Date: 20TH February 2026
Our Ref: P1629-1_0010

Re: An Coimisiún Pleanála (ACP)

Hydrological and Hydrogeological Responses to ACP Further Information Request items relating to the proposed extension to the existing Burial Ground at Drumcliff Burial Ground located at the townland of Drumcliff, Ennis, Co. Clare.

ACP Planning Ref: 323742-25

Figure 5 Site investigations – location of trial pits and geophysical survey lines.

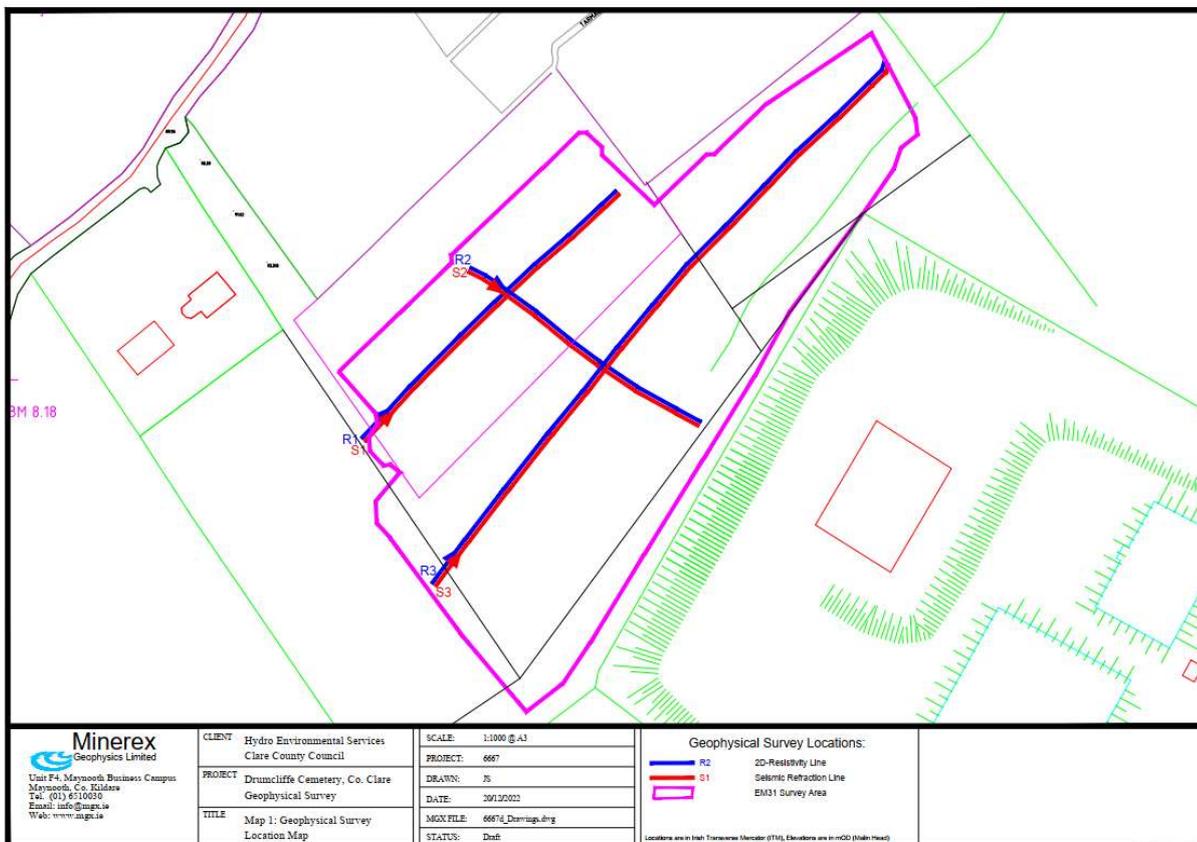
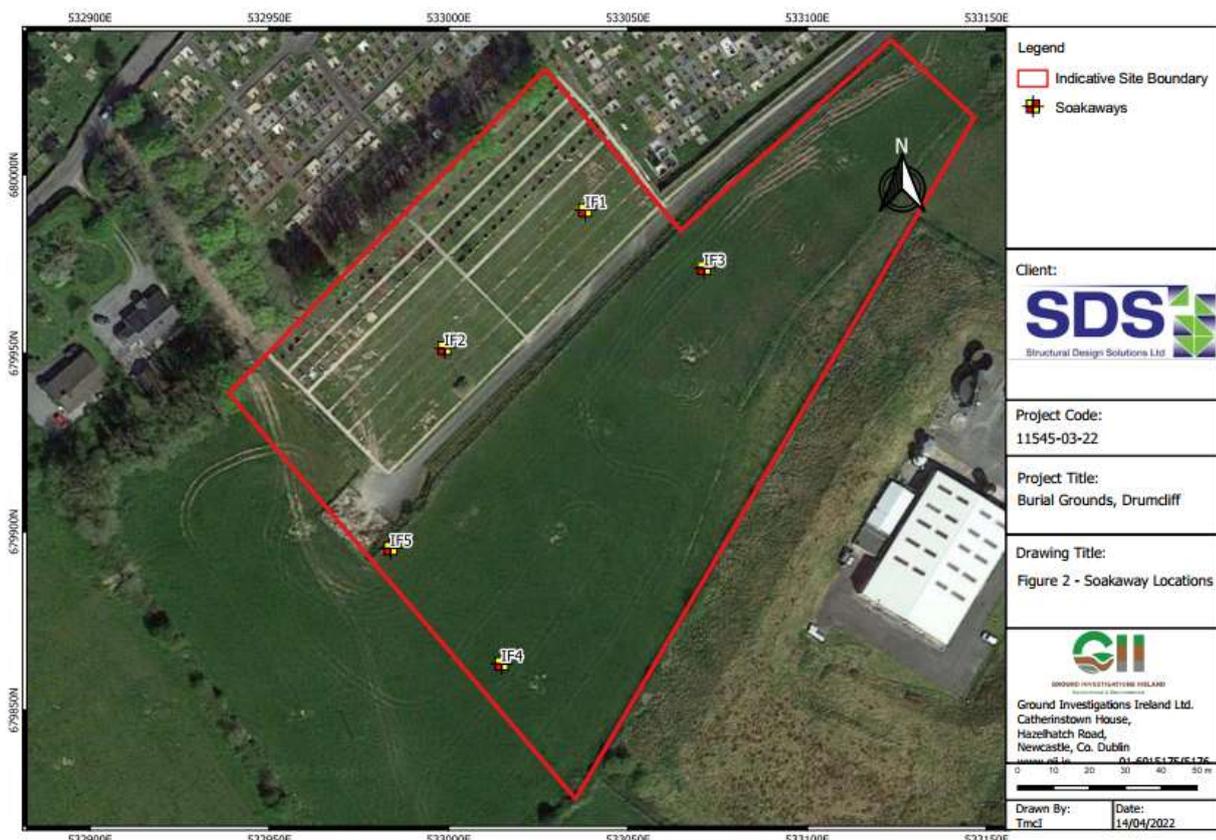
The TOBIN review did note that the trial pits were excavated to a depth of 2m, while a depth of 2.8m would have been preferable in order to definitively determine the soil profile at a depth of 1m below the proposed burial depth (1.8m). However, this was not feasible due to limited access and the inability to track a larger machine through the site. Nonetheless, the trial pit information has been correlated with the geophysical survey information to provide further information on the soil/subsoil profile, with the boulder clay layer interpreted to a depth of 9.5-13.5mbgl.
